DODGE RWD RE TRANSMISSIONS

PUSH-IN TRANSMISSION RANGE SENSOR DIAGNOSIS

CHANGE: At the start of production for the 2002 model year, the Transmission Range Sensor has changed from a screw-in type to a push-in type. The screw-in type had three pins, the push-in type has five pins. The push-in type provides battery voltage or ground on its circuits which would permit starting in Park and Neutral positions only as well as reverse lamp operation. The screw-in type will also convey a drive signal to the PCM. Without this signal the transmission would not shift into fourth gear.

Figure 2

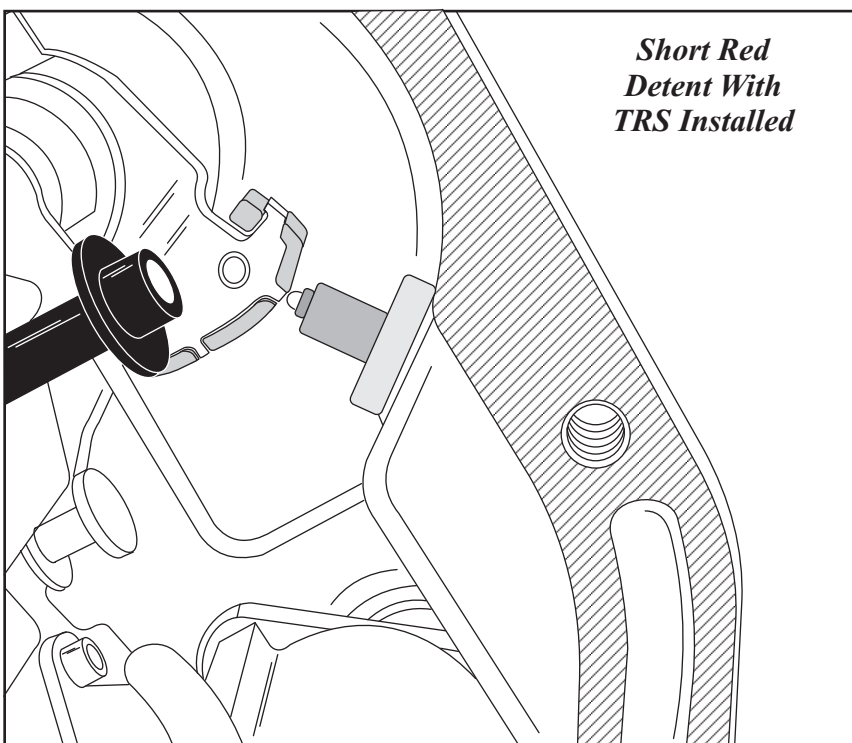
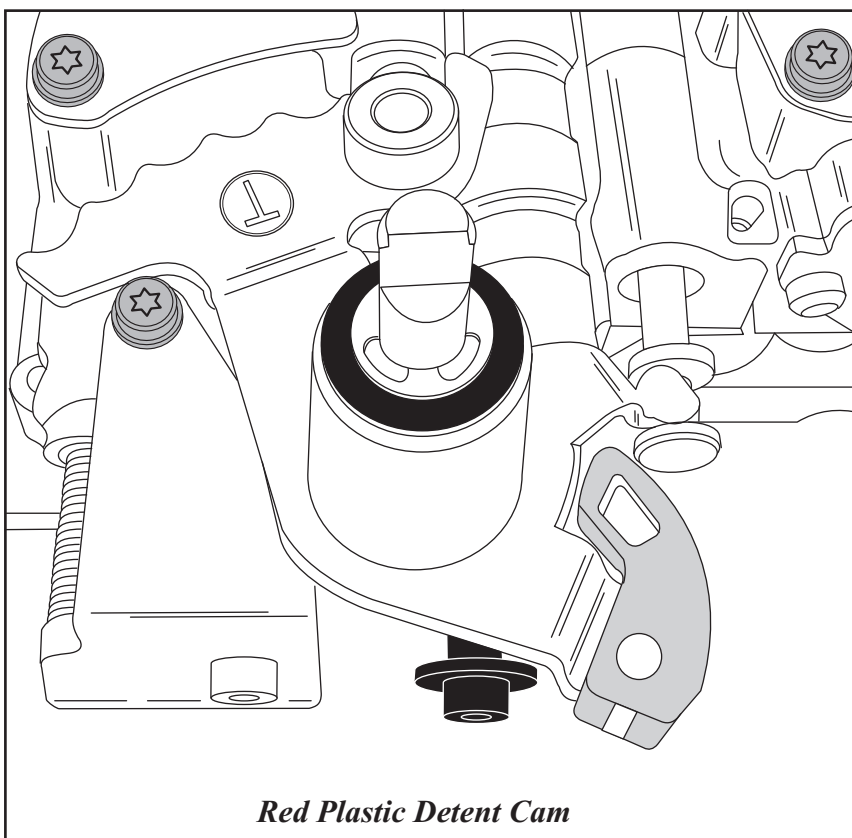
The sensor is mounted in the transmission housing near the valve body, just above the pan rail. It's in the same position as the Park/Neutral switch on other transmissions. The TRS contacts a cammed surface on the manual valve lever (Figure 2). The cammed surface translates the rotational motion of the manual lever into the linear motion of the sensor. The cammed surface on the manual lever is comprised of two parts controlling the TRS signal: The insulator portion contacts the switch poppet when the manual lever is not in PARK or NEUTRAL. The manual lever itself contacts the poppet when the lever is in PARK or NEUTRAL; providing a ground for the signal from the starter relay and the JTEC engine controller.

- (1) The Transmission Range Sensor because it now pushes into a smooth hole in the case and is retained by a hold down bracket and bolt.
- (2) The case because the push-in style case has no threads for the TRS like the previous design case.
- (3) The detent lever on the valve body is shorter to accommodate the longer TRS as seen in Figure 2.

NOTE: Remember to use the correct internal linkage that matches the longer digital sensor as shown in Figure 2.

Figure 5

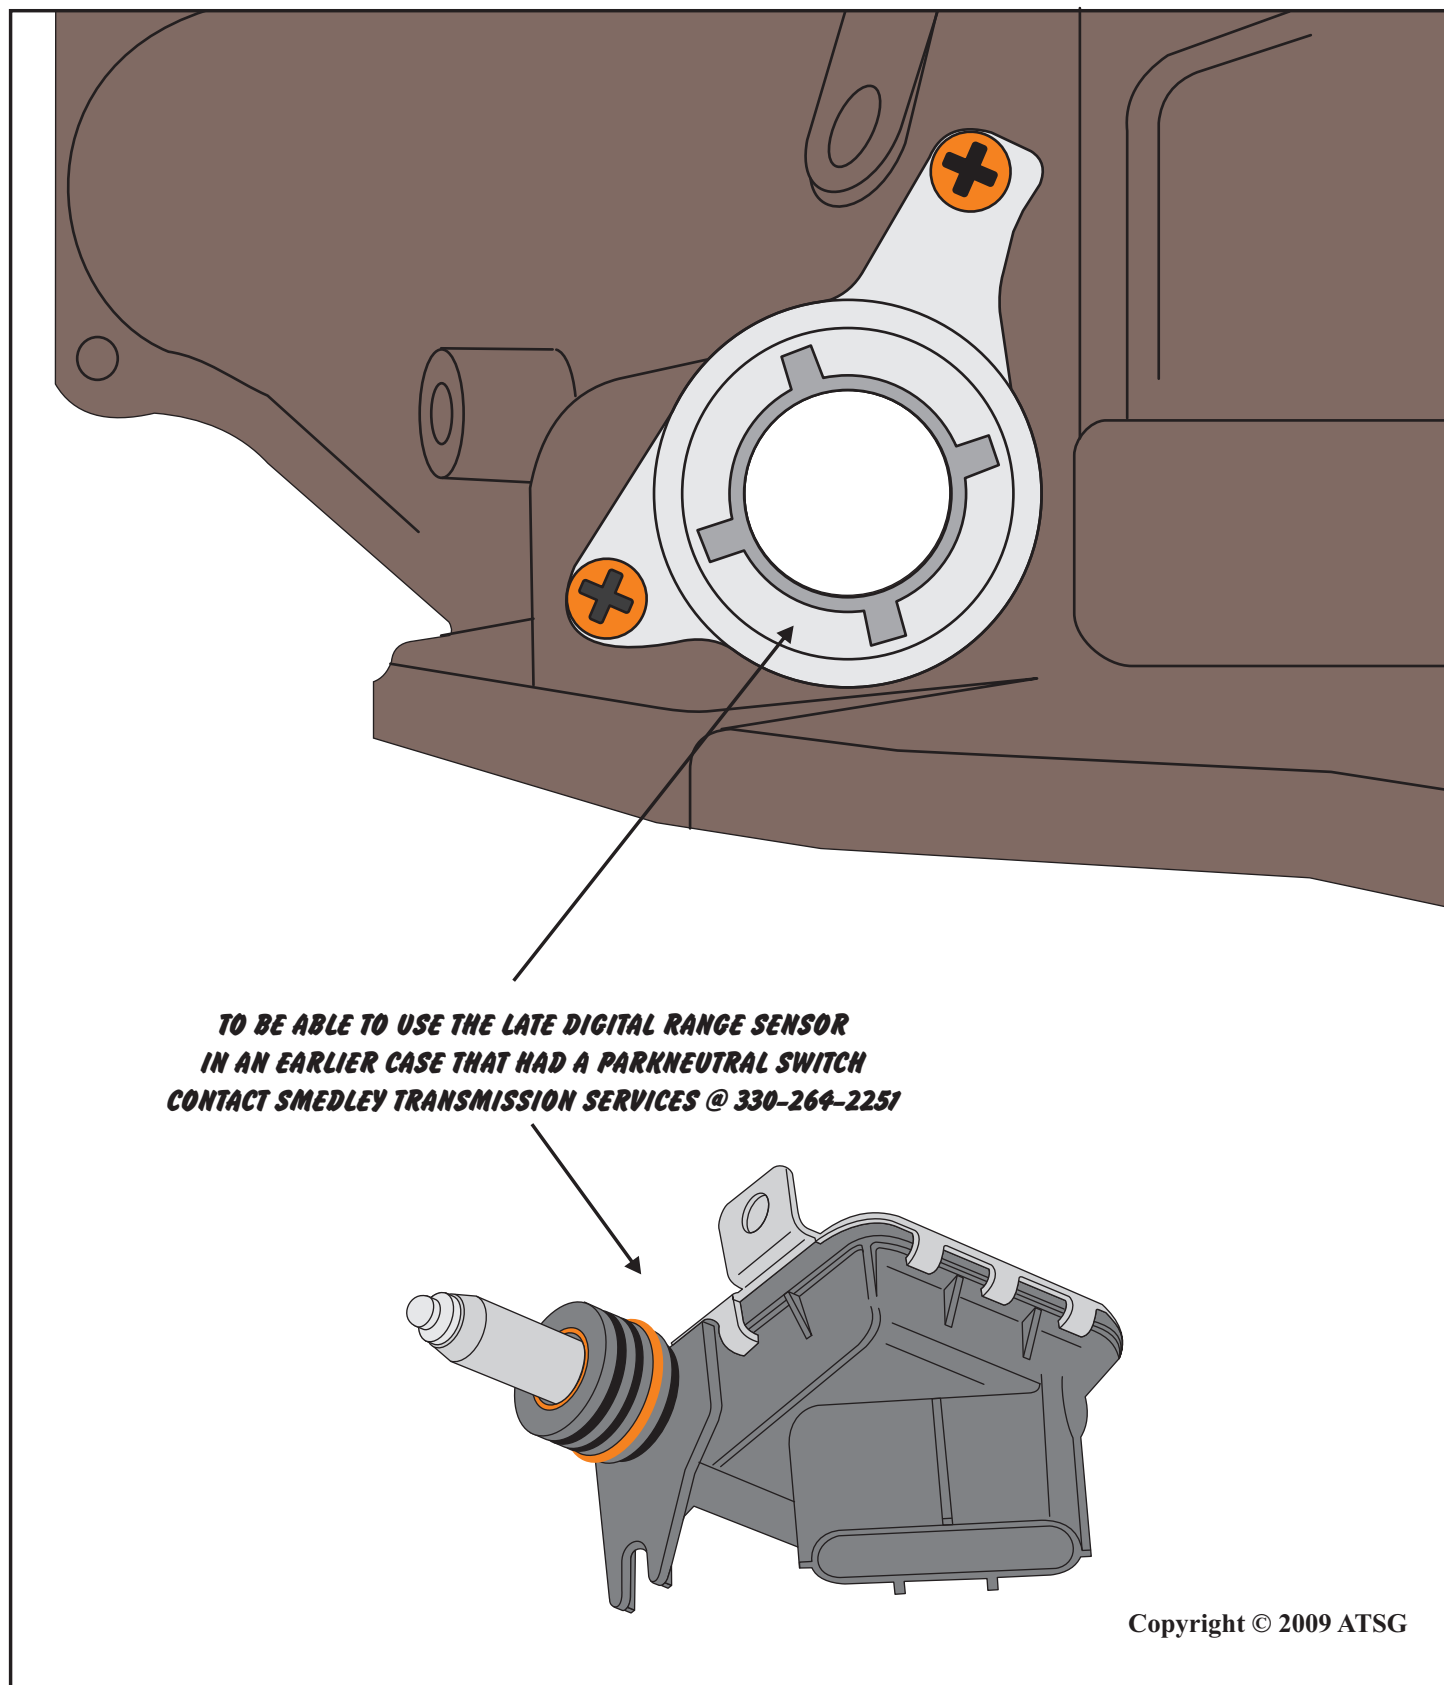
If a case replacement is necessary and all that is available is an early case with the screw-in park/neutral switch, the modified case seen in Figure 5 will accept the later Digital Range Sensor. For more information on this modification contact Smedley Transmission Service at 330-264-2251.
